# Access Compliance Report

### (Curb Ramps)

Intersection ID: 14943	Main Street: REMOUNT_RD	Cross Street: DUNAVANT_ST	Location:	N
ADA ID: 342C82BB9DC0	Ramp Type: PerpDiag	Initial Pass/Fail: Fail	Overall Compliance: No	Severity Score: 12.5

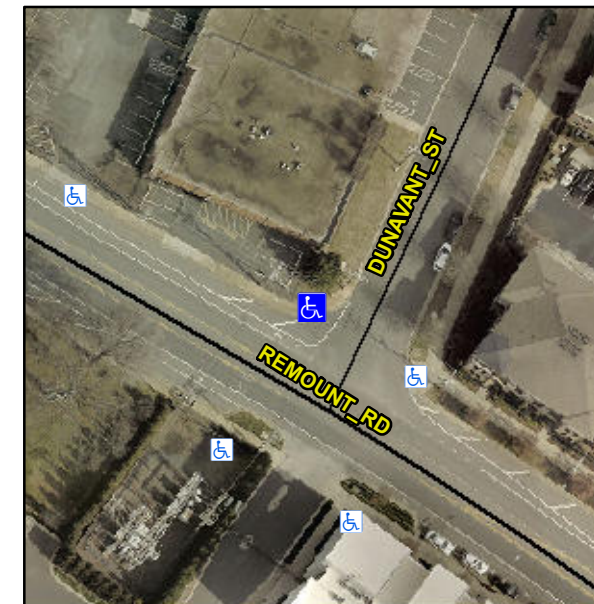
**Not Found, R304.2.2**

Compliance	Description	Data	Compliance	Description	Data
N/A	Ramp Length (in)	59.0	No	Ramp Slope (%)	9.4
Yes	Ramp Width (in)	48.0	Yes	Ramp XSlope (%)	1.9
N/A	Flare Type LT	N/A	N/A	Flare Type RT	N/A
N/A	Flare Slope LT (%)	N/A	N/A	Flare Slope RT (%)	N/A
N/A	Flare Traversable LT?	N/A	N/A	Flare Traversable RT?	N/A
N/A	Landing Length (in)	N/A	N/A	DWS Provided?	N/A
N/A	Landing Width (in)	N/A	N/A	DWS Contrast?	N/A
N/A	Landing Slope (%)	N/A	N/A	DWS Length (in)	N/A
N/A	Landing X Slope (%)	N/A	N/A	DWS Full Width?	N/A
N/A	Landing Curb? (Y/N)	N/A	N/A	DWS Offset (in)	N/A
N/A	Shared Landing?	N/A			
N/A	Gutter Ponding?	N/A	N/A	Gutter Slope (%)	N/A
N/A	Gutter Lip Ht (in)	N/A	N/A	Gutter X Slope (%)	N/A
N/A	Painted X Walk1?	No	N/A	Painted X Walk2?	No
	X Walk 1 Direction	To SW		X Walk 2 Direction	To SE
N/A	X Walk 1 Width (in)	N/A	N/A	X Walk 2 Width (in)	N/A
	X Walk 1 Slope (%)	0.1		X Walk 2 Slope (%)	3.3
	X Walk 1 X Slope (%)	3.5		X Walk 2 X Slope (%)	1.9

**Remove & Replace Curb Ramp With Two New Directional Ramps or Equivalent.**
